HPK/2023/0061- Bridgemont

Landscape comments by Anton Cannell, Derbyshire Landscape and Placemaking

An LVIA has been undertaken for the site by Barnes Walker (Ref: M3645-PA-DOC-01-V02), photos within the assessment are stated as being taken during Feb 2023. I visited the site for the purpose of reviewing the LVIA and producing these comments on 23.06.2023. Overall, I consider that the methodology, scope and process used in the assessment are consistent with the guidelines detailed by GLVIA 3.

Below : map extract from LVIA showing LVIA viewpoints in the vicinity of the PDNP with areas shaded orange-brown to highlight areas with good visibility of the site that are not covered by the LVIA chosen viewpoints.

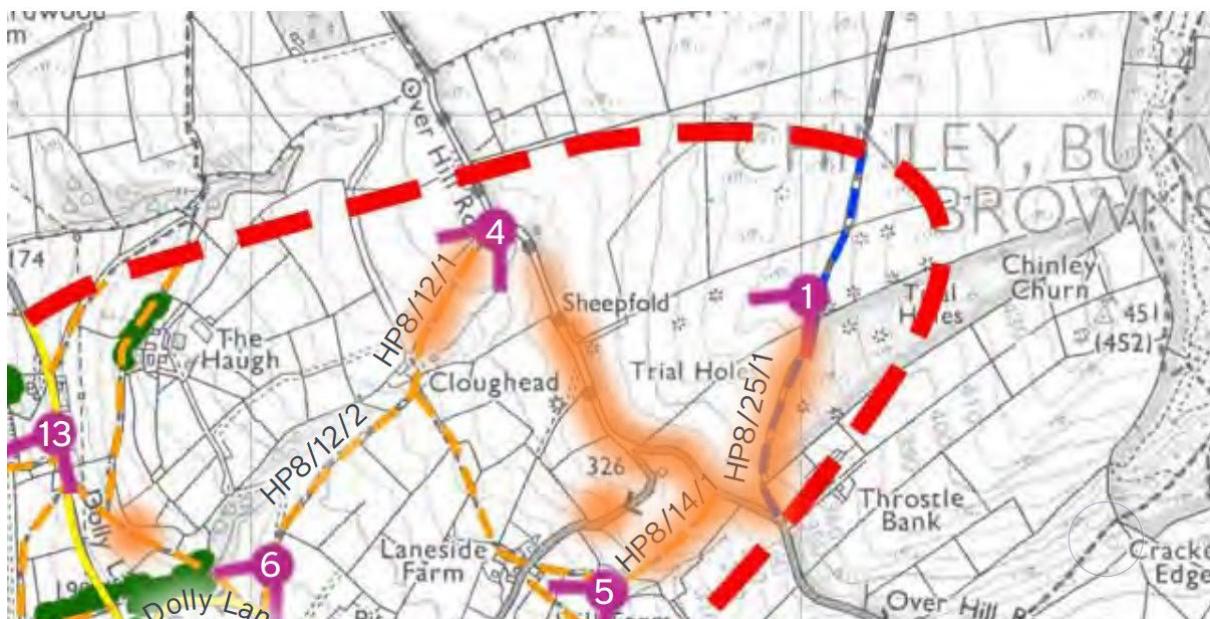
Whilst I agree with the chosen visual envelope for the study area, overall, I do not consider that the chosen viewpoints adequately explore the potential visual impacts. I consider that the positions of the viewpoints and number of viewpoints to the northeast of the site, and particularly within the PDNP, have a tendency to underestimate the potential visibility of the site.

I would agree with this assessment, however it should be noted that there are much better vantage points of the site within the PDNP closer to and below this viewpoint. The viewpoint position chosen has less visibility being further from the site and due to landform. There is better visibility from HP8/25/1 almost continuously descending the PRoW from Viewpoint 1 to Over Hill Road. There is also good visibility along Over Hill Road including the unsurfaced section of Over Hill Road where it continues beyond the surfaced road switchback. This track runs along the boundary of the PDNP, it is classified as 'other routes with public access' and is well used by walkers (see map below).

Photo below-Overhill Road surfaced section (along boundary of PDNP)

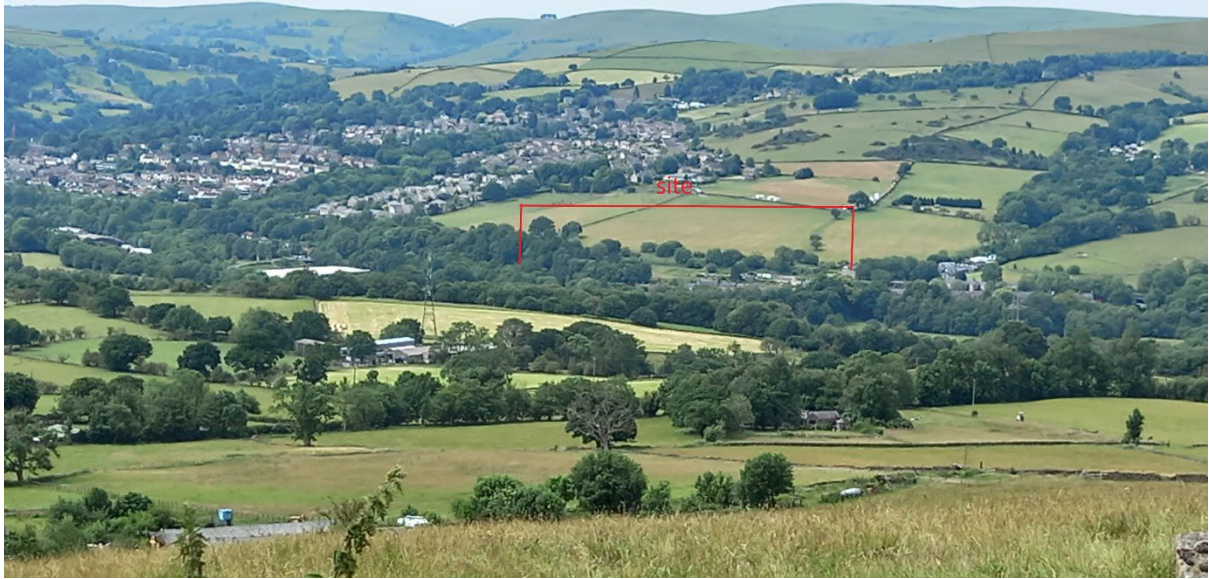
See photos below taken from positions along the routes shaded orange-brow on the map extract above showing good visibility of the site.

Overall, I would agree with many of the assessments of likely visual effects, however, I consider that it is important to consider views in more detail than covered by the LVIA in the areas to the northeast of the site around the boundaries and within the PDNP. In these areas there is considerably more visibility that has not been represented in the LVIA.
